WESTAR ADDITION SEDGWICK COUNTY, KANSAS

RE: SUB 2003-135 -- One-Step Final Plat of Westar Addition

STAFF REPORT

CASE NUMBER: SUB 2003-135 -- WESTAR ADDITION

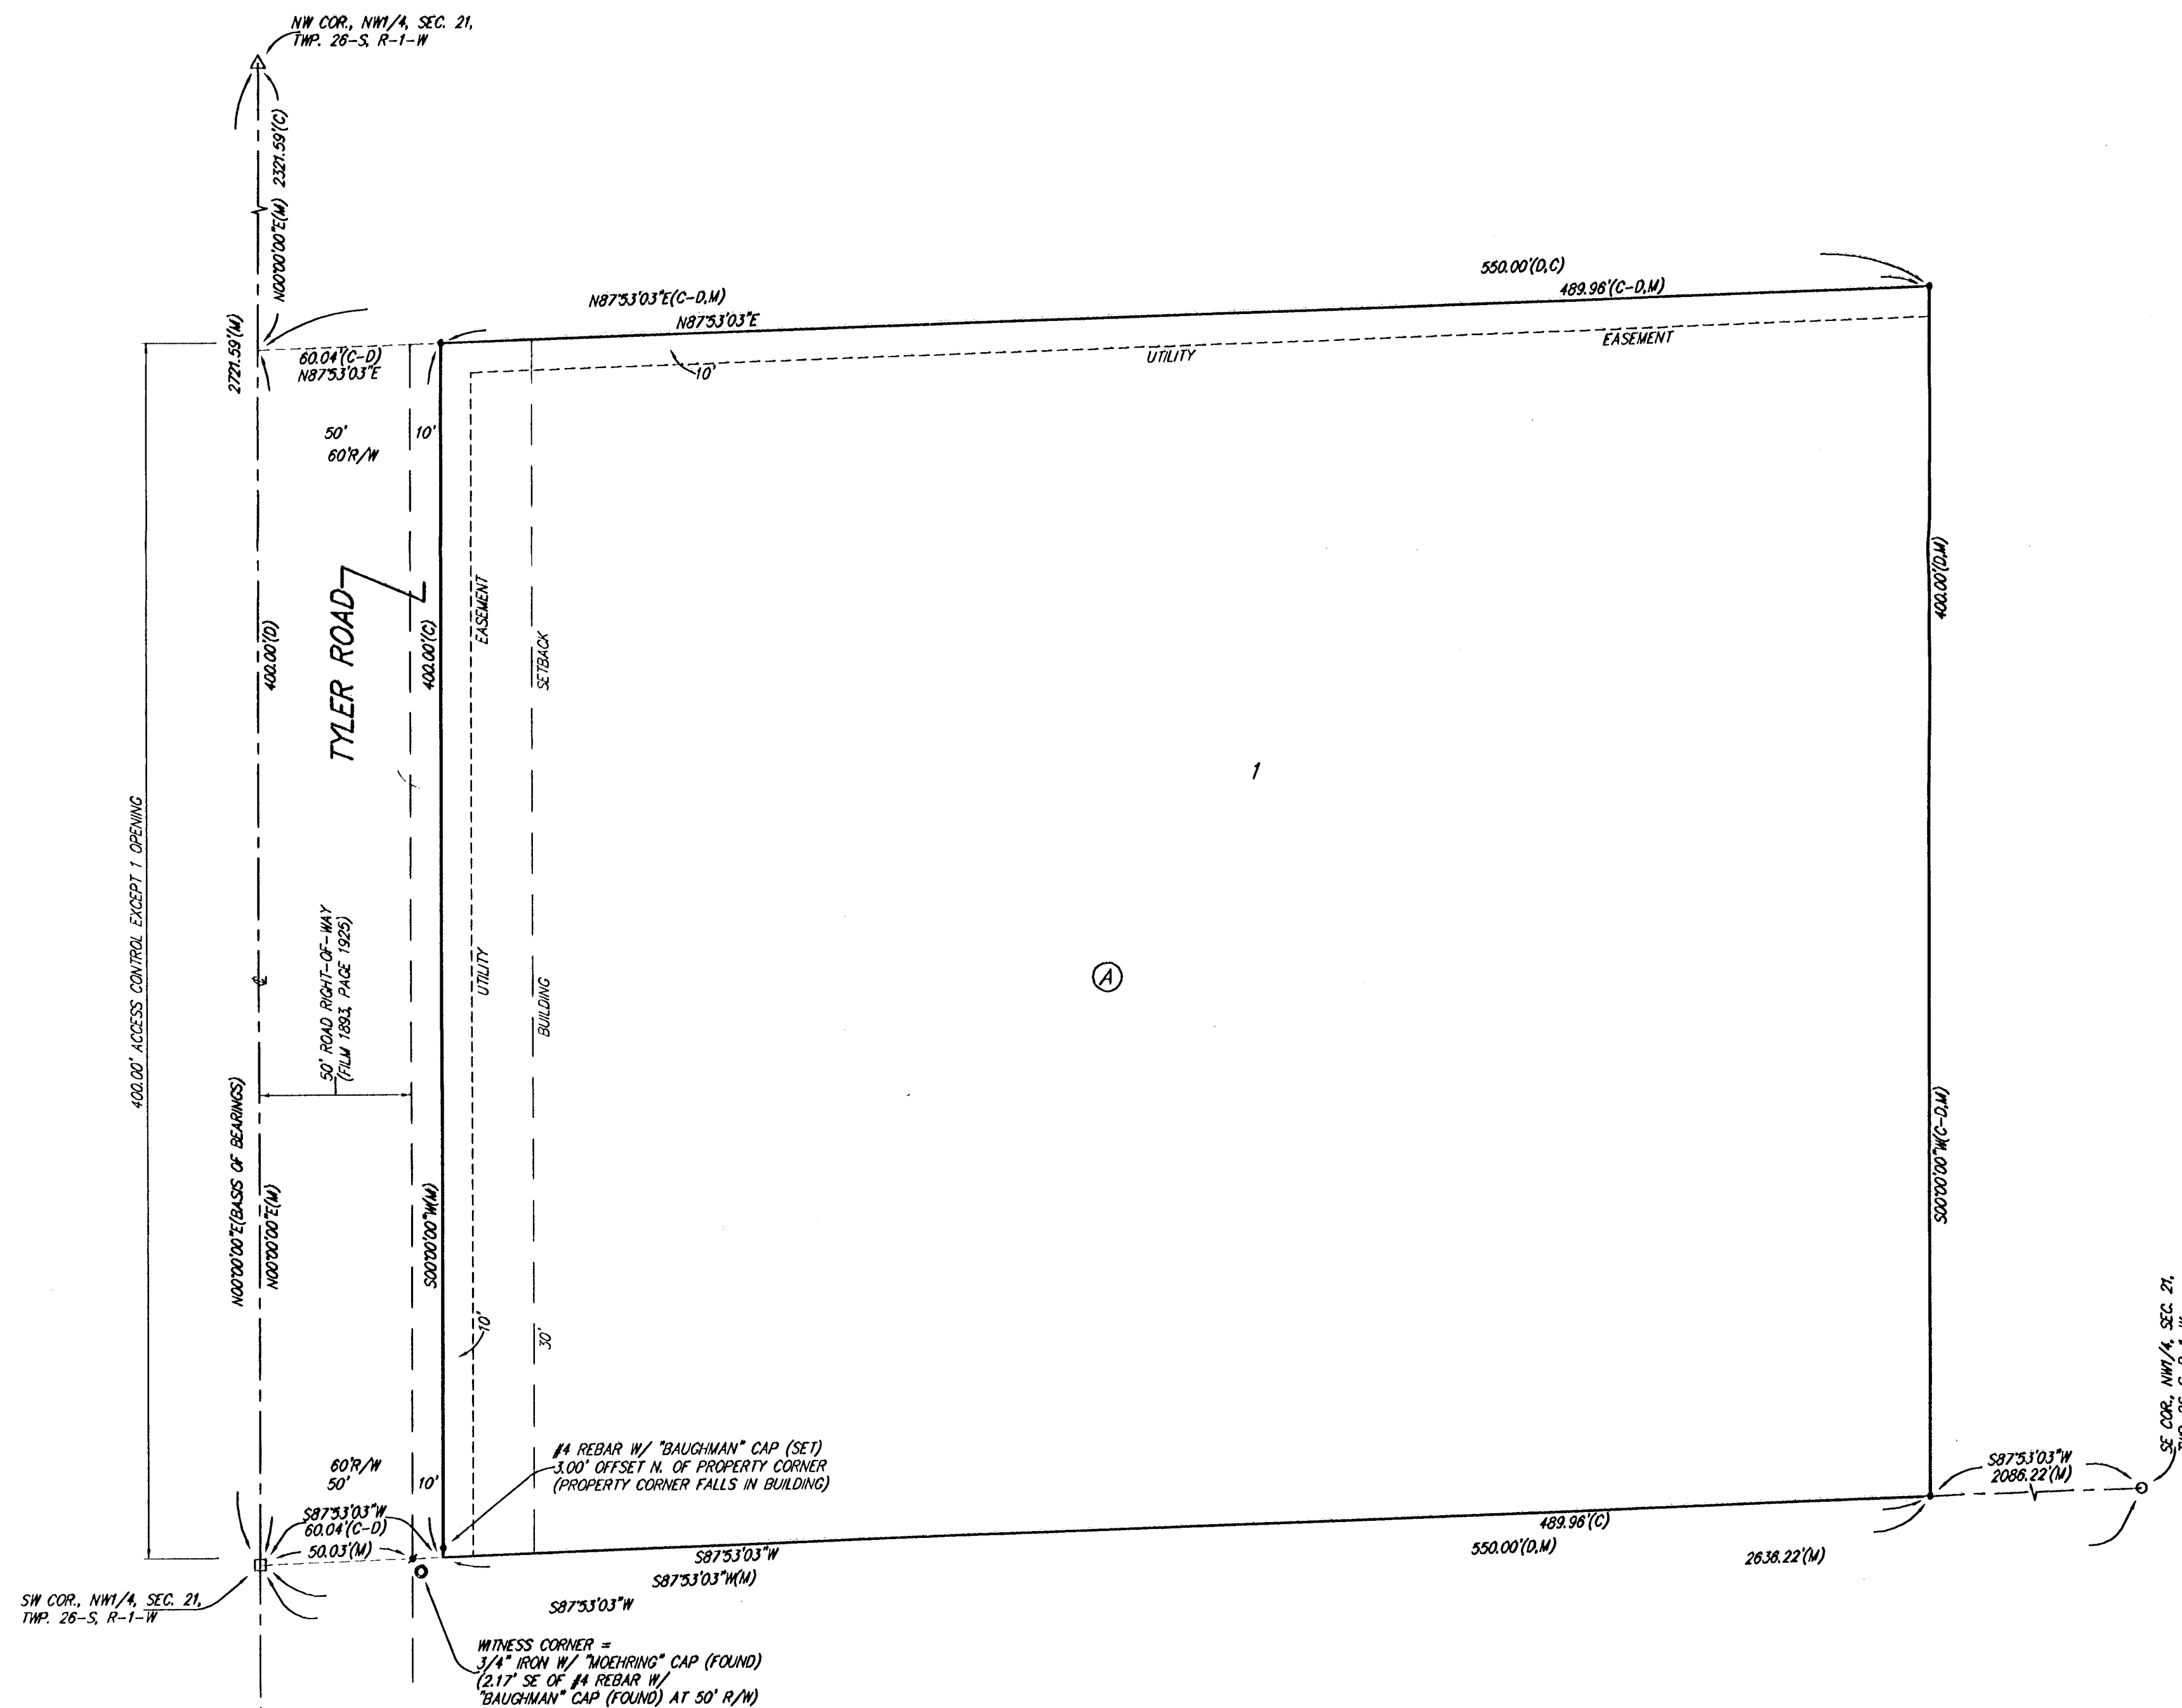
- A. County Engineering needs to comment on the status of the applicant's drainage plan. *The drainage plan is approved.*
- B. County Engineering needs to comment on the access controls. The plat denotes one opening along Tyler. The site plan denotes this opening to be 123 feet from the south property line. *The access controls are approved.*

- C. The final plat tracing shall reference the dedication of access controls in the plat's text to the "appropriate governing body".
- D. Per Sedgwick County Fire Department, access drives to any structure in excess of 150 feet from the edge of the roadway will need to be installed prior to final framing inspection, preferably before the start of any above grade construction work. Such drive to be installed according to fire department specifications: (1) Twenty feet of drivable surface is provided the entire length of the access drive designed to withstand the weight of fire apparatus in inclement weather with provisions for turning fire apparatus around. (2) To meet fire department specifications, the surface will need to be an all-weather material consisting of rock or gravel, ground asphalt, laid asphalt or concrete. It is to be applied a minimum of 4 inches in depth consistently over the entire width and length of the driving surface (gravel is prone to problems during extended periods of rain or snow and should be used with caution unless a good solid compacted base has been installed).

- E. This property is within a zone identified by the City Engineers' office as likely to have groundwater at some or all times within 10 feet of the ground surface elevation. Building with

specially engineered foundations or with the lowest floor opening above groundwater is recommended, and owners seeking building permits on this property will be similarly advised. More detailed information on recorded groundwater elevations in the vicinity of this property is available in the City Engineers' office.

- H. The platting text shall include language that a drainage plan has been developed for the plat and that all drainage easements, rights-of-way, or reserves shall remain at established grades or as modified with the approval of the applicable City or County Engineer, and unobstructed to allow for the conveyance of stormwater.

- N. Perimeter closure computations shall be submitted with the final plat tracing.
- O. Recording of the plat within thirty (30) days after approval by the City Council and/or County Commission.

- A. County Engineering needs to comment on the status of the applicant's drainage plan. *The drainage plan is approved.*
- B. County Engineering needs to comment on the access controls. The plat denotes one opening along Tyler. The site plan denotes this opening to be 123 feet from the south property line. *The access controls are approved.*

- C. The final plat tracing shall reference the dedication of access controls in the plat's text to the "appropriate governing body".
- D. Per Sedgwick County Fire Department, access drives to any structure in excess of 150 feet from the edge of the roadway will need to be installed prior to final framing inspection, preferably before the start of any above grade construction work. Such drive to be installed according to fire department specifications: (1) Twenty feet of drivable surface is provided the entire length of the access drive designed to withstand the weight of fire apparatus in inclement weather with provisions for turning fire apparatus around. (2) To meet fire department specifications, the surface will need to be an all-weather material consisting of rock or gravel, ground asphalt, laid asphalt or concrete. It is to be applied a minimum of 4 inches in depth consistently over the entire width and length of the driving surface (gravel is prone to problems during extended periods of rain or snow and should be used with caution unless a good solid compacted base has been installed).

- E. This property is within a zone identified by the City Engineers' office as likely to have groundwater at some or all times within 10 feet of the ground surface elevation. Building with specially engineered foundations or with the lowest floor opening above groundwater is recommended, and owners seeking building permits on this property will be similarly advised. More detailed information on recorded groundwater elevations in the vicinity of this property is available in the City Engineers' office.

- H. The plat's text shall include language that a drainage plan has been developed for the plat and that all drainage easements, rights-of-way, or reserves shall remain at established grades or as modified with the approval of the applicable City or County Engineer, and unobstructed to allow for the conveyance of stormwater.

- N. Perimeter closure computations shall be submitted with the final plat tracing.
- O. Recording of the plat within thirty (30) days after approval by the City Council and/or County Commission.
